Los Angeles Lakers Headquarters

**Request for Information**

RFI 149 - Visitor/Staff Entry Curtainwall

<i>Document Ref.</i>	<i>Number</i>	<i>Title</i>	<i>Revision</i>
	A-341	Section & Details at Visitor Staff Entry	Nov 20, 2015 - No: 2

A-341

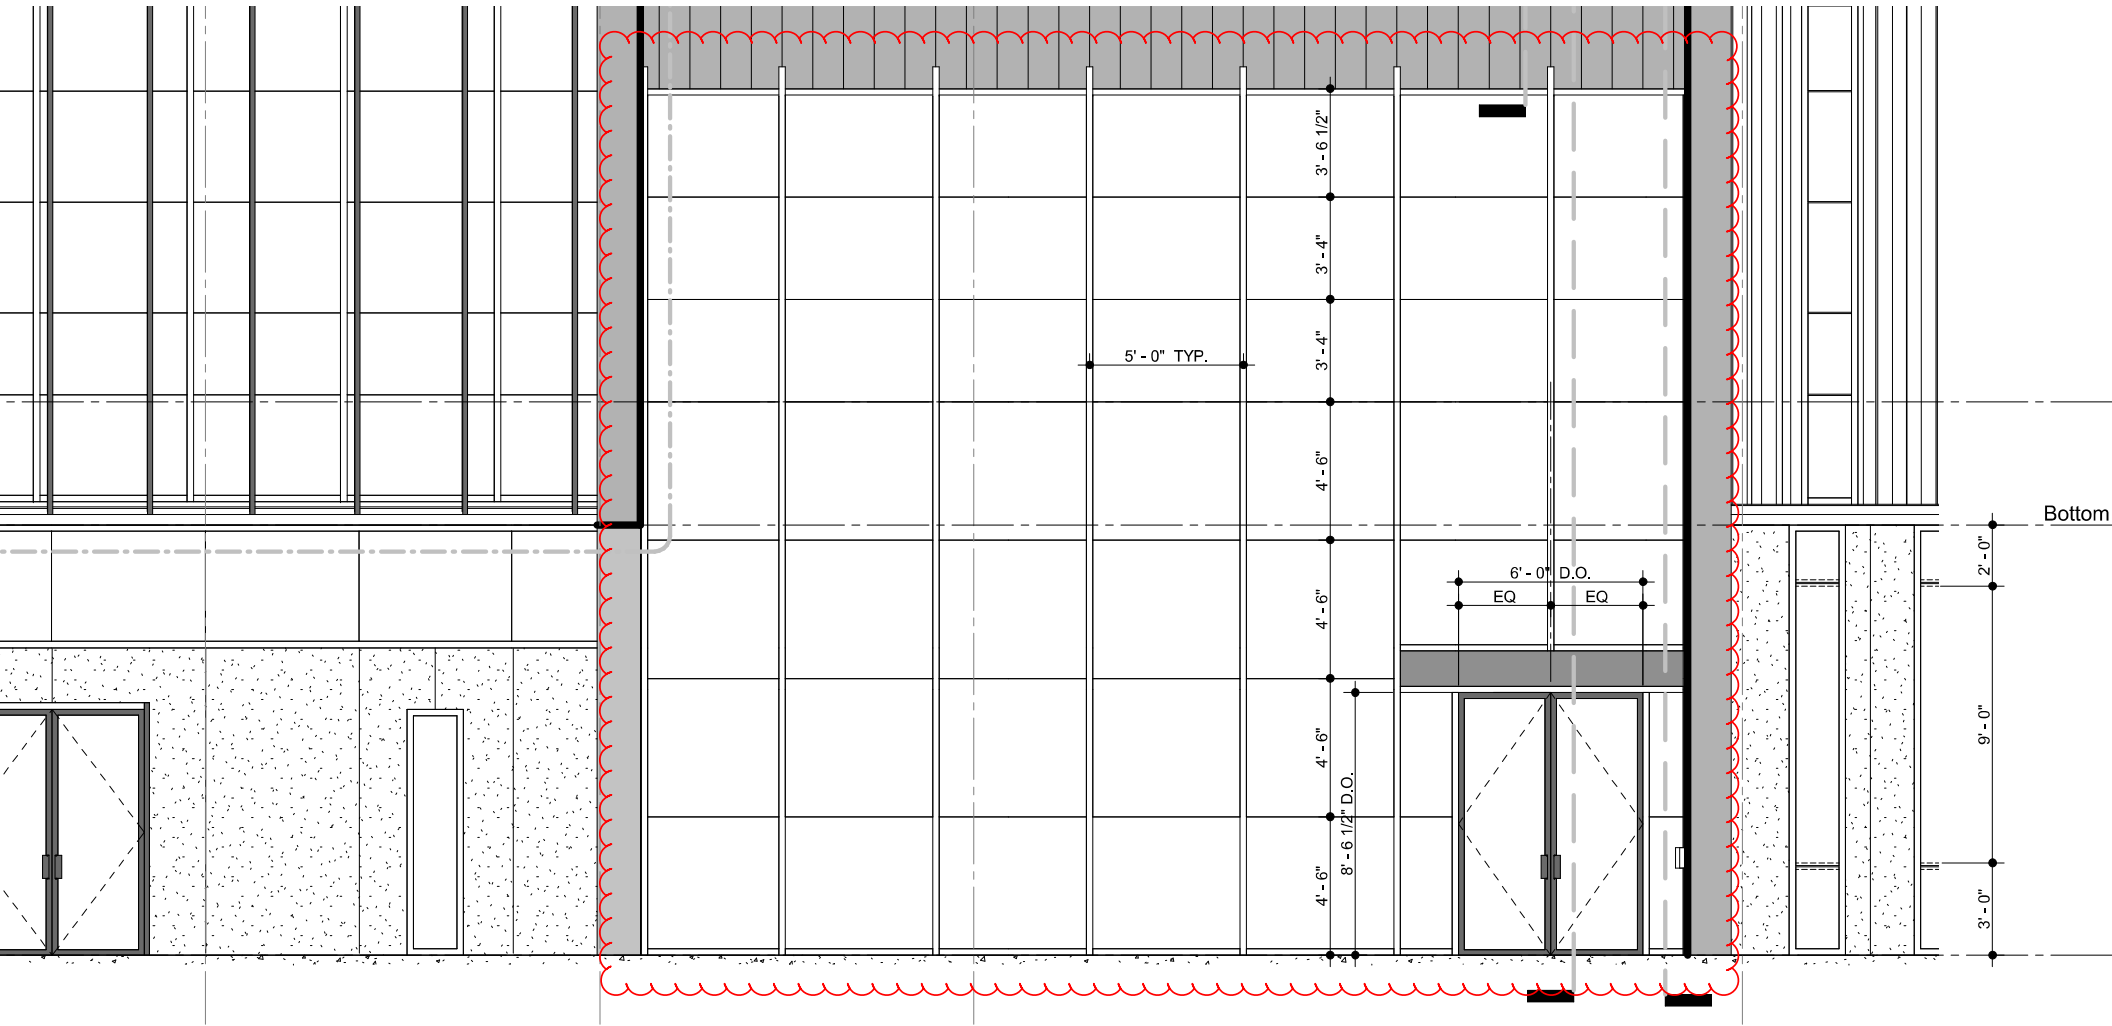
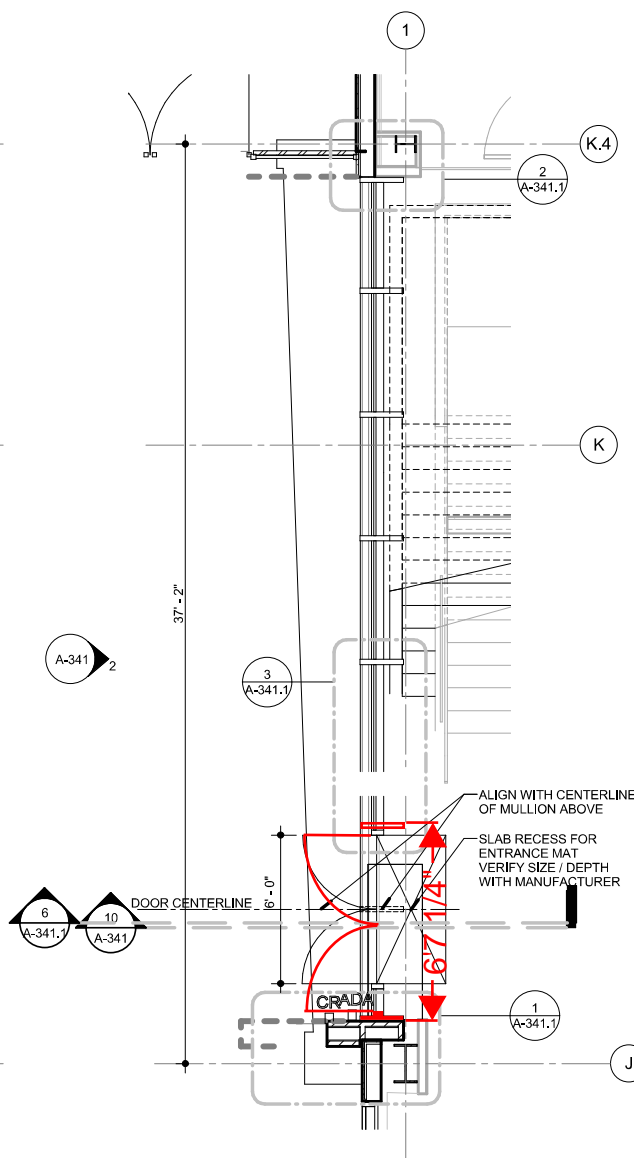
Please advise on the following Visitor/Staff Entry Curtainwall issues.

1. Please confirm the fascia above the curtainwall will be independent from the curtainwall system and not attached in anyway. REF: MCC-SK-RFI 149-1.
2. Can the fascia above the curtainwall be moved in front of the curtainwall system? REF: MCC-SK-RFI 149-1.
3. Please confirm the 2,300 pound load per mullion on the beam has been accounted for. REF: MCC-SK-RFI 149-1.
4. In order the meet the window load with a single span 33'-4" curtainwall system please confirm the modifications to alignment as shown in the attached MCC-SK-RFI 149-2 through MCC-SK-RFI-149-4 are acceptable This will simplify the door header condition.

[1 & 2] see IFC drawings detail 9/341.1 for changes.
[4] see markups on MCC-SK-RFI 149-3.

3. A horizontal wind load of 2300lb load per mullion at ASD level applied to the beam is acceptable. Please note the beam is a flat rectangular HSS per drawings dated 1/22/16.
